Subject: Calvert Cliffs Nuclear Power Plant
Units Nos. 1 & 2; Dockets Nos. 50-317 & 50-318
Spent Fuel Pool Modification: Supplementary Information

Reference (a) requested an amendment to allow increased spent fuel storage capacity at Calvert Cliffs. The following information is pertinent to that request.

Enclosures: (1) Bechtel letter dated 12/3/81 from Ventura to Ash,
Spent Fuel Pool, Storage Capacity.
(2) Plan for Fuel Storage Rack Arrangement, NES
Document No. 81A0701 page 6 of 29.

PLAN
 FUEL STORAGE RACK ARRANGEMENT (1000 CELLS)
 (SOUTHERN POOL)

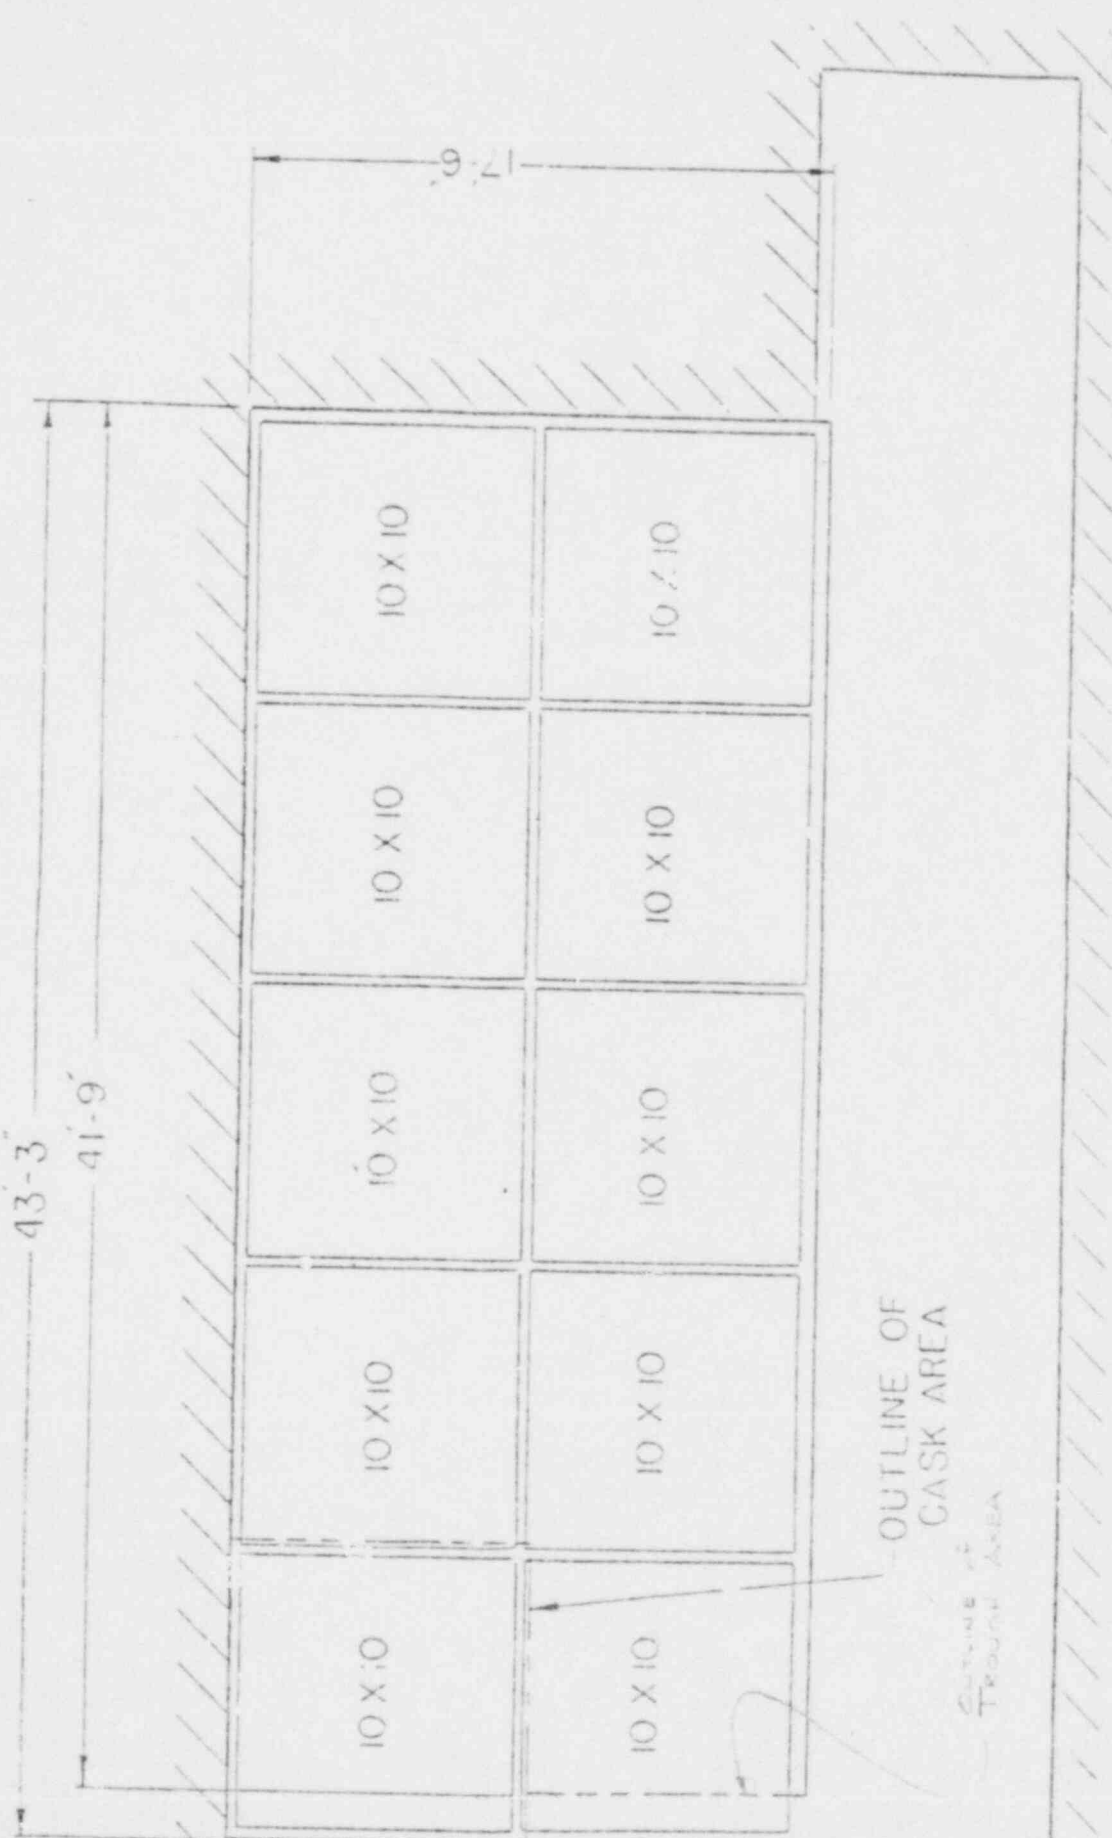
The cask area and the trough area, as shown on Enclosure (2), will be raised in spent fuel pool number 2 to the same elevation as the existing pool floor. These raised areas will meet the compression capacity of the existing pool floor and all seismic Class I requirements. The areas will be raised by the use of a free-standing structural steel insert that will be compatible with the pool environment. The additional forces added by the inserts during a seismic event should not affect the integrity of the racks or their contents due to the conservative structural design of the racks. The integrity of the pool liner plate will be maintained.
